Town of Riverhead

East Main Street Urban Renewal Plan Update 2008

Final Generic Environmental Impact Statement

August 2008

Figure 2-2
Zoning Map

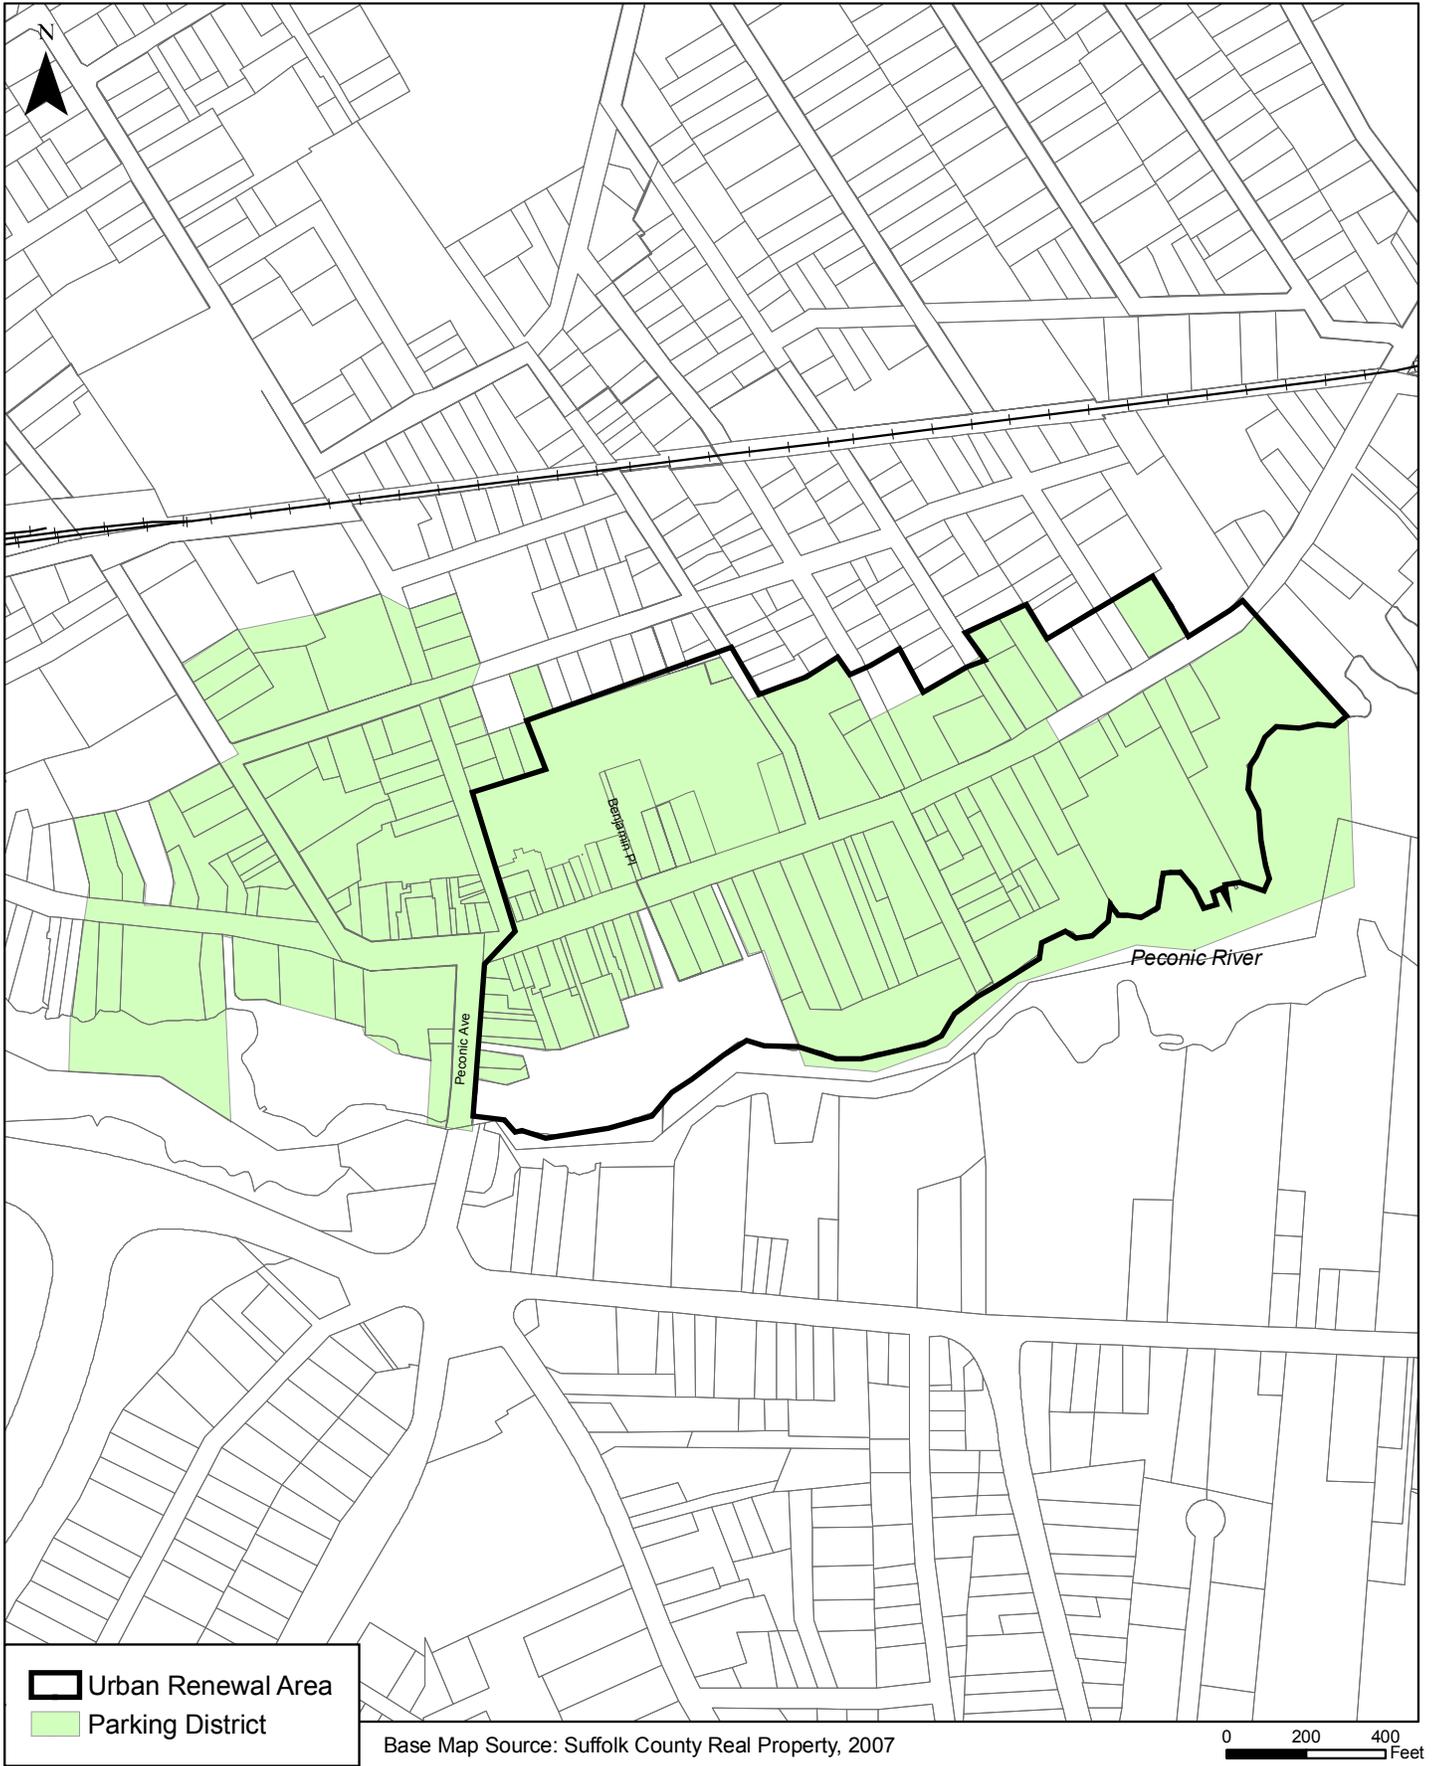
Comment 2-1: The zoning district map should be amended so that the DC-1 and DC-2 boundaries are accurately shown. (Sendlewski)

Response 2-1: Figure 2-2, “Zoning Map,” has been amended (see attached).
